Shop Drawing Submittal Review

Project Name: Webster University-**ISB**

Copies	No.	Description
1 PDF	221116P01A	(Submittal No.'s) -
		(Cannon #221116-001) – (Paric #15051-0257) – (WES #607)
		• **Domestic Water Piping Product Data REV 1 - Resubmittal**

Specification Description: Domestic Water Piping

FABRICATED FLANGE PIPES

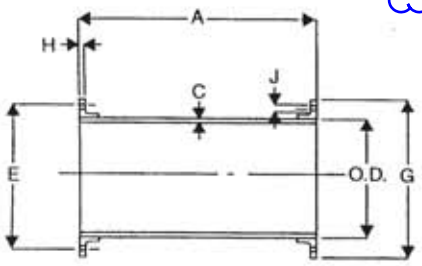
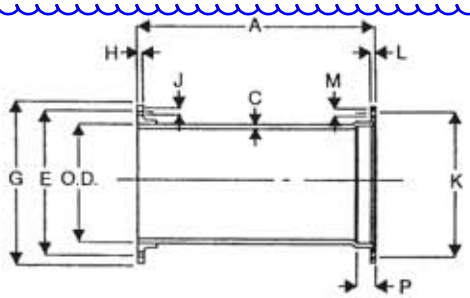
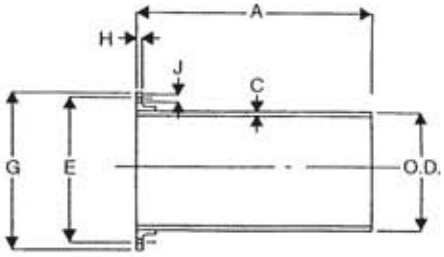
Size per Drawings to be 8"

Type and size not indicated on submittal. Mark on the submittal page the type/style that is intended for this project.
